VIRGINIA ELECTRIC AND POWER COMPANY  
RICHMOND, VIRGINIA 23261

**VIRGINIA ELECTRIC AND POWER COMPANY**  
**NORTH ANNA POWER STATION UNITS 1 AND 2**  
**REVISIONS TO STATION EMERGENCY PLAN**  
**REVISIONS TO EMERGENCY PLAN IMPLEMENTING PROCEDURES**

**VIRGINIA ELECTRIC AND POWER COMPANY  
REVISIONS TO NORTH ANNA POWER STATION EMERGENCY PLAN  
AND EMERGENCY PLAN IMPLEMENTING PROCEDURES**

## ATTACHMENT 2 NORTH ANNA EMERGENCY PLAN REVISION 17 SUMMARY

**FIGURE 7.1**

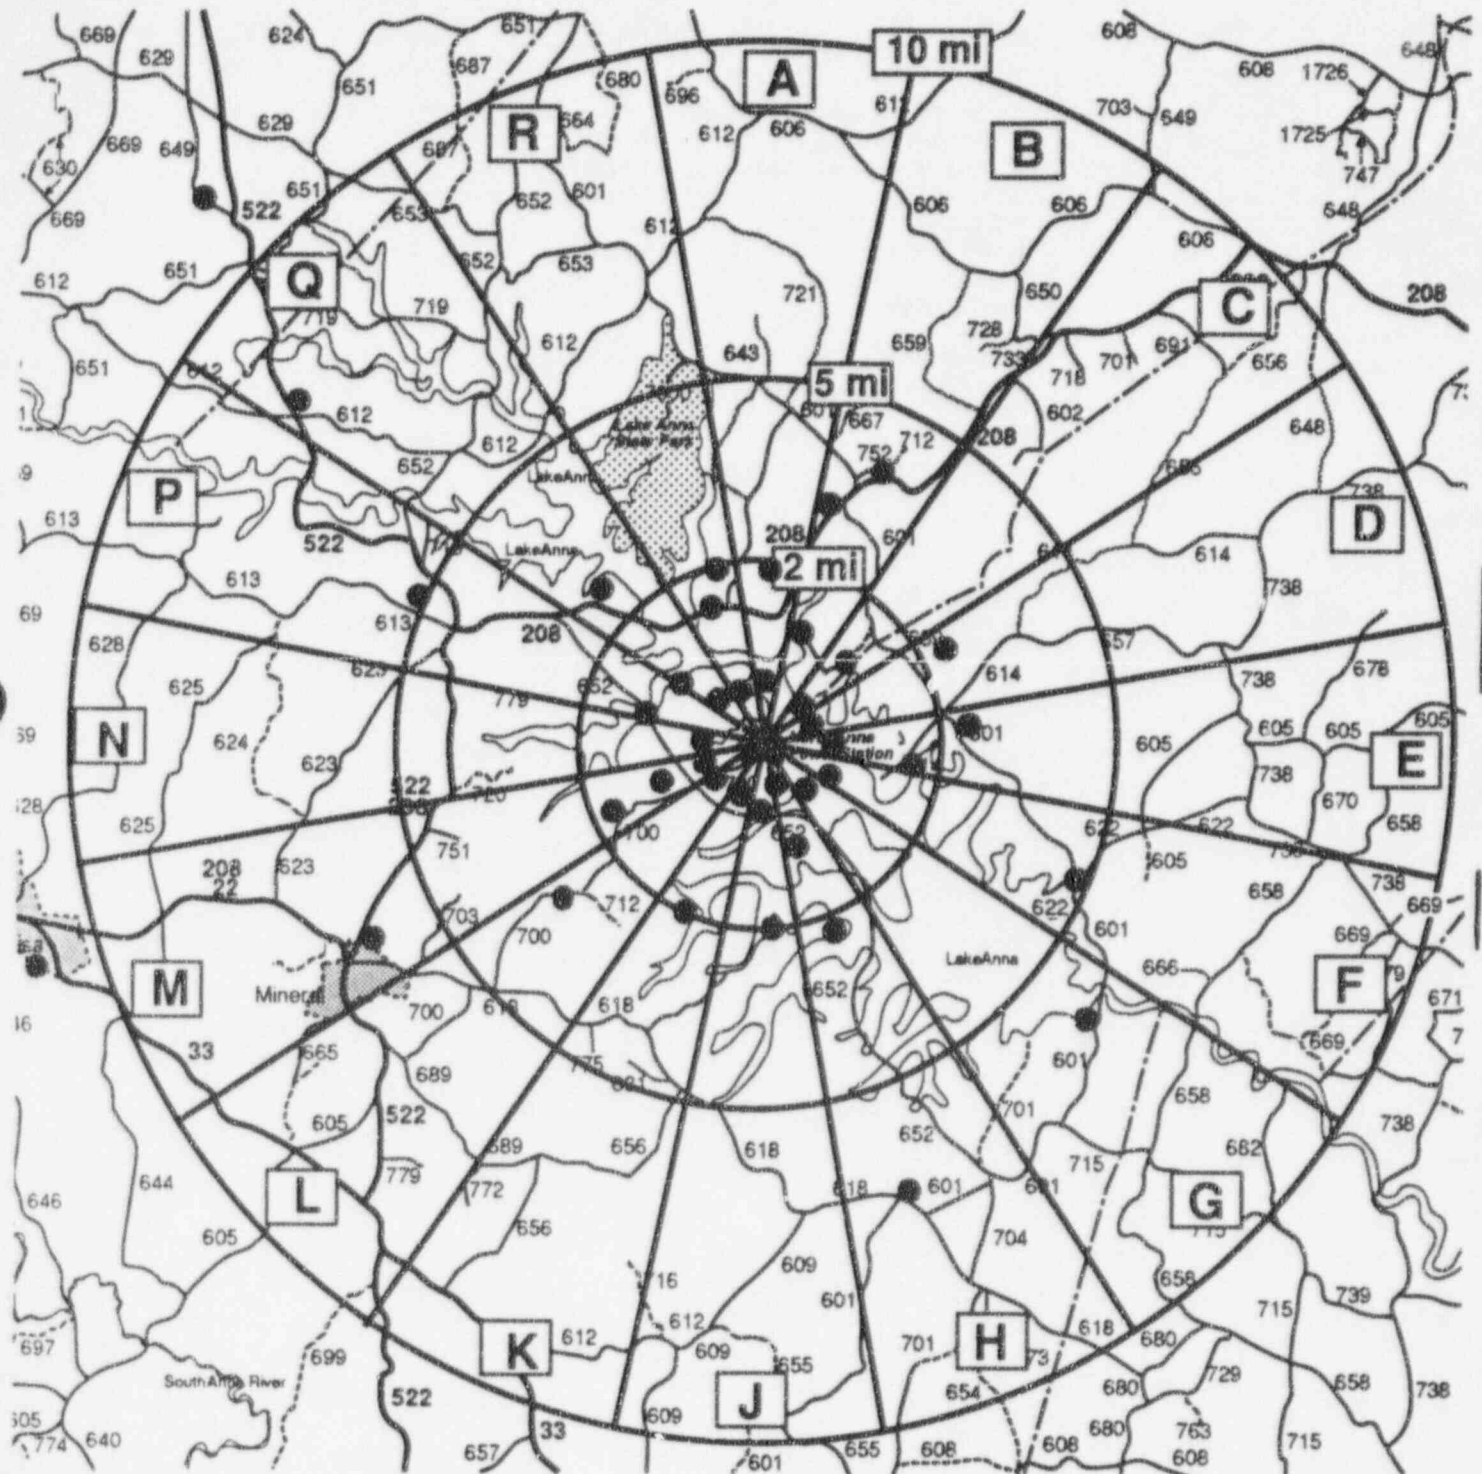
Updated monitor location listing and removed non-emergency plan (i.e. environmental) TLDs in Figures 7.1 and 7.2.
